FOUNDATION REPORT

Avila Beach Drive at US 101 Interchange Improvements

Retaining Walls N1 and W1

Draft Type Selection Report, Field Infiltration Testing Memo, and Foundation Review Comment Sheet

Figure 2: Proposed Layout (Wallace Group 2021b, 2021c)

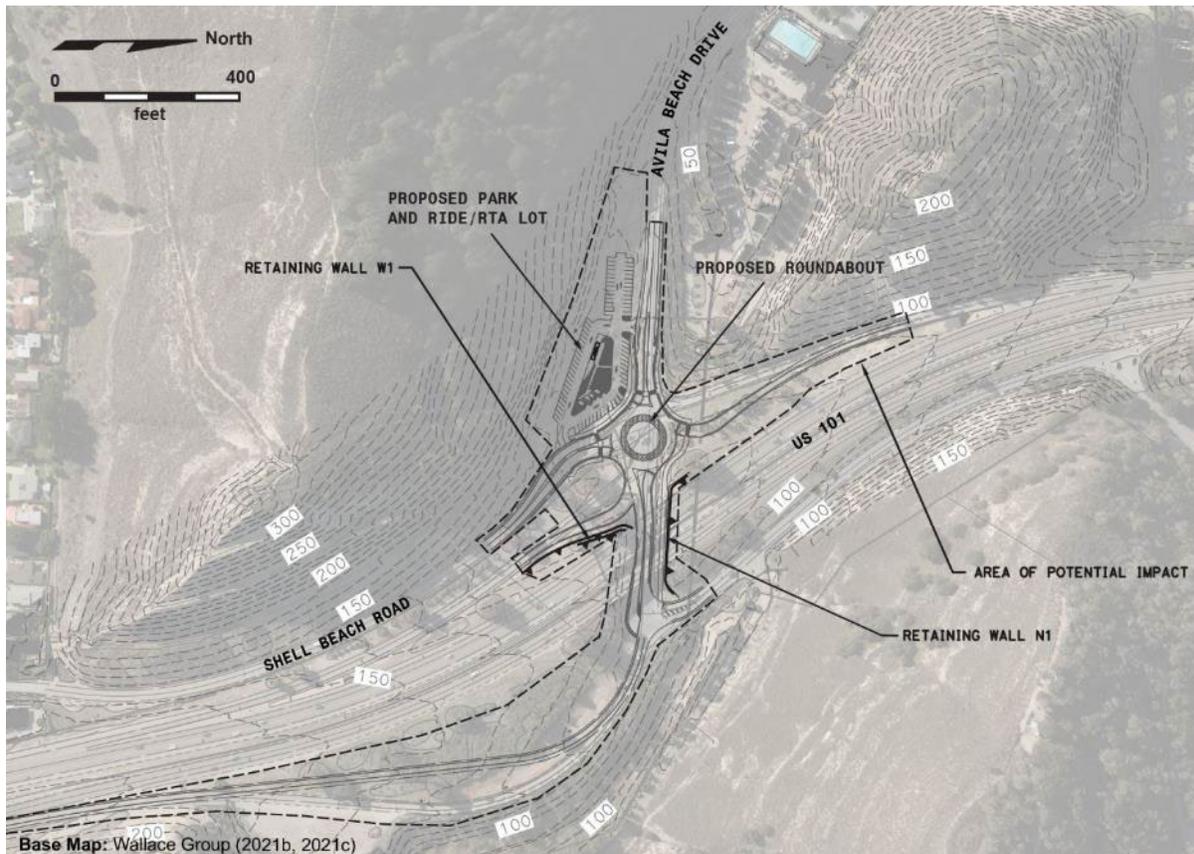
P-2	FR/Section 2.1		Please provide the vertical datum reference for the "elevation 97 feet".	Yeh will provide datum to NAVD88 – <i>Completed 9-23-22</i>
P-2	FR/Section 2.2		<ol style="list-style-type: none"> Figure 2 indicates WG 2021b and 2021c; however, 3rd line indicates WG 2021a and 	<ol style="list-style-type: none"> No change needed

Figure 3: Field Exploration Plan

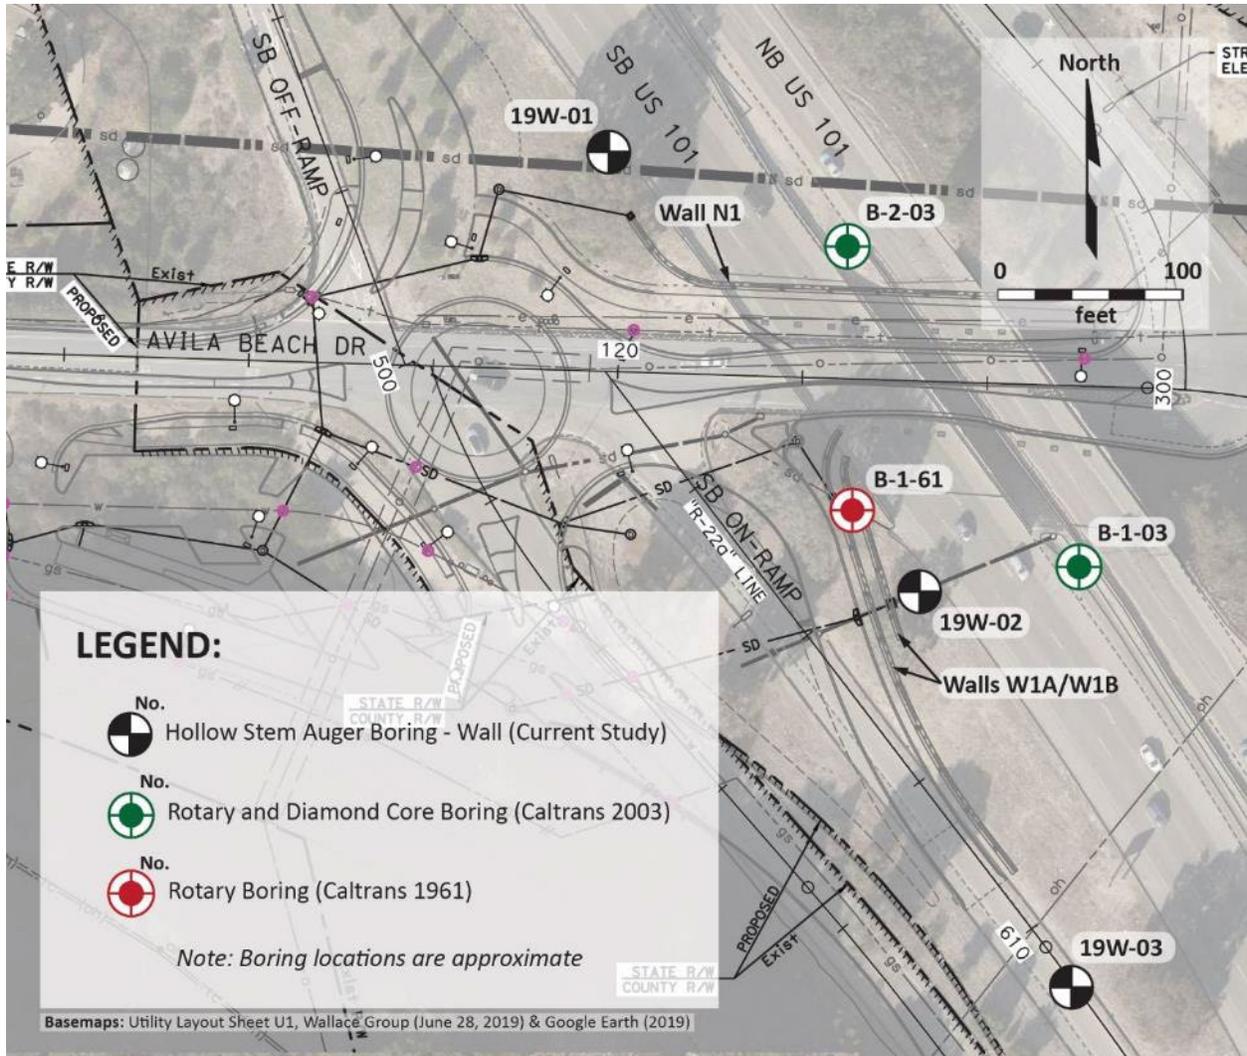
P-5	FR/Section 4.2/Figure 3		<p>It seems like boring 19W-01 and 19W-03 were drilled away from retaining wall line. Please provide clarification/justification in the write up.</p>	<p>Walls are located on an area with existing steep slopes which made locating borings along the exact alignment impractical. Walls will be in artificial fill and we judged the boring locations selected by Yeh in</p>

Figure 5: Caltrans ARS Curve

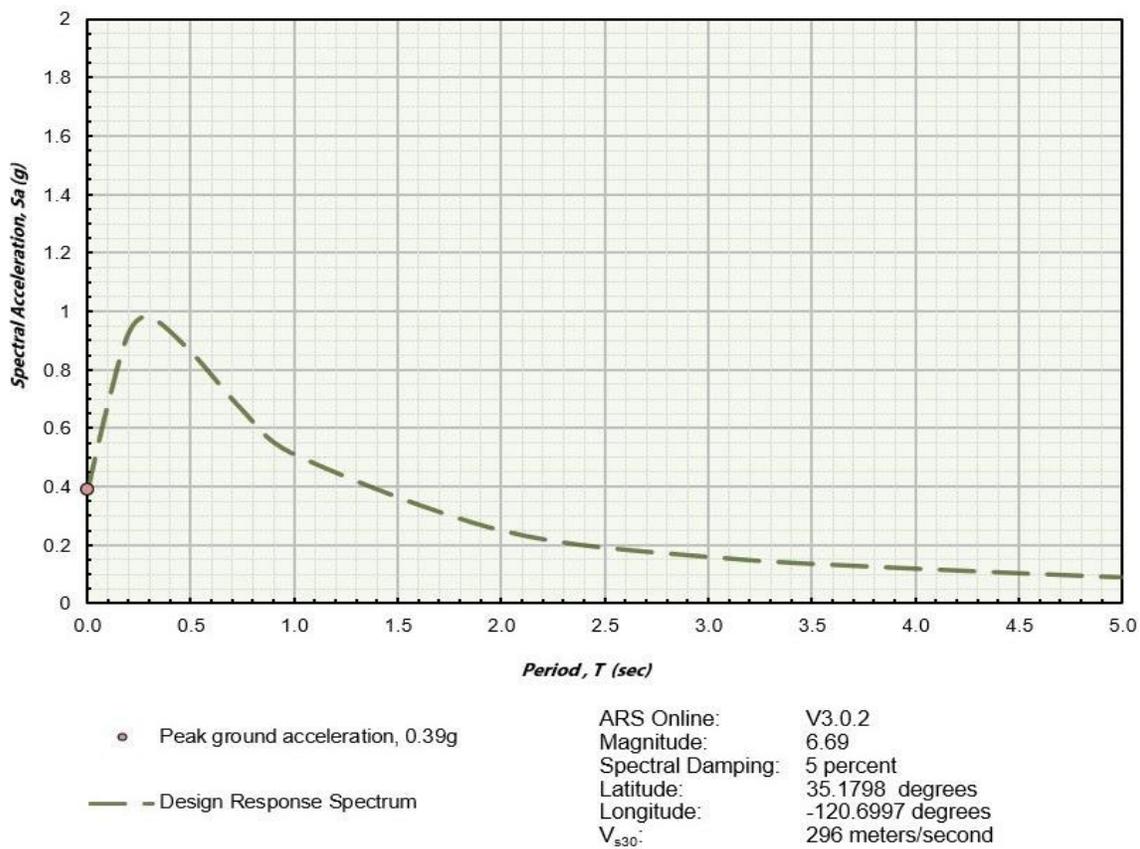
#	Doc. (See Note 1)	Page, Section, or SSP	Review Comments	Consultant Responses	✓
5	FR	Page 13	ARS curve is not required for retaining wall design. Recommend removing the Figure 5.	Comment noted. The ARS curve is provided as a basis for the seismic design. It is provided as additional pertinent design information.	
6	FR	Page 17	<p>Table 6,</p> <p>Geotech is not recommending the ground anchor vertical and horizontal spacing, and foundation soil factored nominal bearing resistance for facing.</p> <p>Instead, need to provide the apparent earth pressures (AEP) for wall (active, and passive). Please estimate the AEP or since soil properties are provided, let structure estimate them.</p> <p>e.g. <i>“To determine lateral pressures for the soldier pile wall, Figure 3.11.5.7-1 (b) of section 3.11.5.7 – Apparent Earth Pressures (AEP) for Anchored Walls (active and passive) from AASHTO LRFD Bridge Design Specifications, Eighth Edition, shall be used.”</i></p>	<p>Tables for Ground Anchor and Soil Nail Walls do include columns with recommendations for “maximum Ground Anchor Vertical Spacing”, “Maximum Ground Anchor Horizontal Spacing”, and “Foundation Soil Factored Nominal Bearing Resistance for Facing”. Updated values will be provided in the final version of the FR.</p> <p>Geotechnical design properties were provided in the Foundation Report for the structure designer for use with estimating the AEP. Yeh will clarify the AASHTO LRFD Bridge Design AEP figure 3.11.5.7-1(b) should be used in the design.</p>

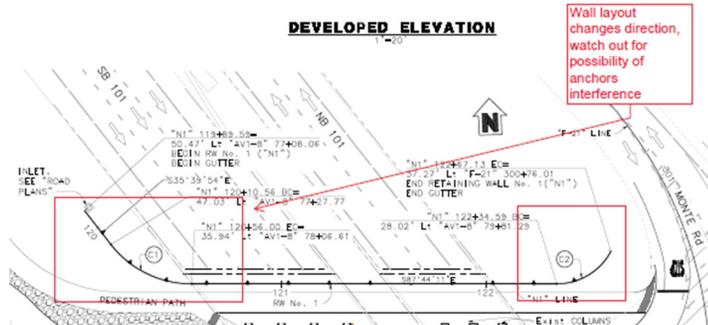
Page/Sheet No.	Section	Paragraph	Comment	Response
16	Foundation Report		<p>DRAFT Foundation Report Avila Beach Drive at US 101 Interchange Improvements</p> <p style="text-align: right;">Yeh Project No. 216-423 April 14, 2021</p> <p>conducted on every anchor). Anchor loads were calculated using the Tributary Area Method (FHWA 1999) using a load factor of 1.35 that was applied to the Apparent Earth Pressure diagram per AASHTO <i>LRFD Bridge Design Specifications</i> (2020) Table 3.4.1-2. For a maximum wall design height of 16 feet, three anchors were modeled with a 4-foot vertical spacing, 5-foot horizontal spacing and a 15-degree anchor declination. The analysis resulted in a total anchor force of 46.1 kips plus a 2.65-kip reaction force acting on the base of the wall. The lowest most anchor should be designed to include the reaction force acting at the base of the wall. Individual anchor forces beginning 4 feet below the top of the wall were $T_1 = 17.1$ kips, $T_2 = 14.5$ kips, and $T_3 = 14.5$ kips. These loads will double using a 10 foot horizontal spacing. A 0.5-foot drill hole diameter and length of 40 feet was used to calculate an ultimate anchor pullout resistance of 94 kips.</p> <p>Internal seismic static analysis was performed using the Mononobe-Okabe theory and limit equilibrium method. The active resultant force required acting at one-half the wall height is the active resultant force required acting at one-third of 0.39g (a_{max}) or 0.13g. An active force due to seismicity is required on the wall face to obtain a resistance factor of 0.9.</p> <p>See attached '216-423 DRAFT Avila Beach Dr Interchange Foundation Report 04-14-2021, GW Comnts.pdf'</p>	Mark Thomas is providing structural design recommendations and calculations for the wall design.
